Updated 2016 6420 Head Components

Left Side Beater Post	Right Side Beater Post	Cross Tube
Part Number: 155525	Part Number: 155524	Part Number: 152537

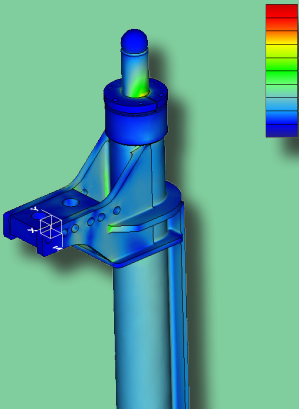
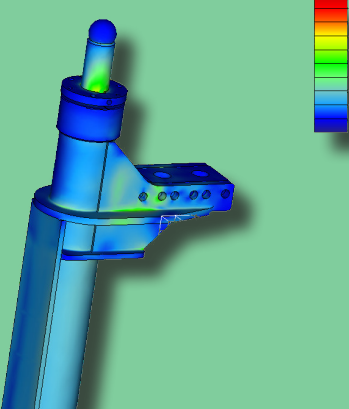
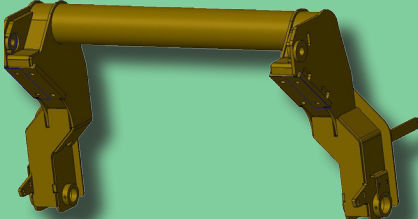
Using strain gauge data acquired from the 2015 season and advanced analysis tools, Oxbo engineers have improved the strength and longevity of the rear beater posts and the cross tube. These updated features are standard on Model Year 2016 6420; existing 6420s can be upgraded to the new design.

The new beater posts feature material changes and different construction techniques that combine to reduce the stress—even in difficult picking conditions—on the parts and increase their service life. The improved construction of the cross tube also reduces stress to enhance performance.

Advanced analysis images highlight reduced part stress
